# Access Compliance Report

## Public Rights-of-Way

### (Curb Ramps)

Intersection ID: N/A	Main Street: DIXIE_RIVER_RD	Cross Street: GLENBURN_LN	Location: SW
ADA ID: D5D496964078	Ramp Type: Directional1	Initial Pass/Fail: Fail	Overall Compliance: No
Severity Score: 12.5			
Codes/Mitigation Info/Possible Solution		Field Measurements/Component Compliance

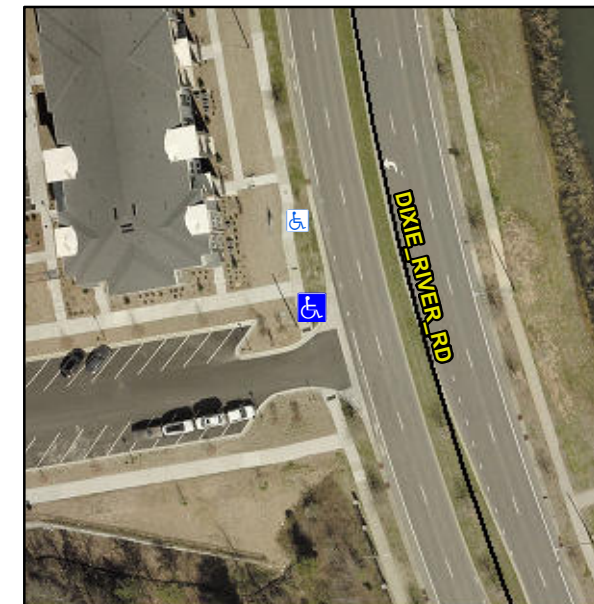
**R304.2.2**

Compliance	Description	Data	Compliance	Description	Data
N/A	Ramp Length (in)	72.0	N/A	Grade Break?	N/A
Yes	Ramp Width (in)	71.0	N/A	Grade Break Slope (%)	0.0
No	Ramp Slope (%)	9.1	N/A	Grade Break XSlope (%)	0.0
Yes	Ramp XSlope (%)	1.9			
N/A	Flare Type LT	N/A	N/A	Flare Type RT	N/A
N/A	Flare Slope LT (%)	N/A	N/A	Flare Slope RT (%)	0.0
N/A	Flare Traversable LT?	N/A	N/A	Flare Traversable RT?	N/A
N/A	Landing Length (in)	0.0	N/A	DWS Provided?	N/A
N/A	Landing Width (in)	0.0	N/A	DWS Contrast?	N/A
N/A	Landing Slope (%)	0.0	N/A	DWS Length (in)	N/A
N/A	Landing X Slope (%)	0.0	N/A	DWS Full Width?	N/A
N/A	Landing Curb? (Y/N)	N/A	N/A	DWS Offset LT (in)	N/A
N/A	Shared Landing?	N/A	N/A	DWS Offset RT (in)	N/A
N/A	Gutter Ponding?	0.0	N/A	Gutter Slope (%)	N/A
N/A	Gutter Lip Ht (in)	0.0	N/A	Gutter X Slope (%)	N/A
N/A	Painted X Walk1?	No		Road Slope (%)	3.5
	X Walk 1 Direction	To NW		Road X Slope (%)	1.8
	X Walk 1 Width (in)	N/A		Clear Space?	N/A

X Walk 1 Slope (%)	3.5	N/A	Clear Space to XWalk (in)	N/A
	X Walk 1 X Slope (%)	1.8	N/A	Storm Grate/Utility Hazard?	N/A
N/A	Ramp inside XWalk1?	N/A		Storm Grate/Utility Type	
N/A	Any Obstructions?	N/A			N/A
	Obstruction Type		Yes	Surface Condition? (G/P)	Good
			N/A	Curb Slope (%)	16.1

**Remove & Replace Entire Ramp.**
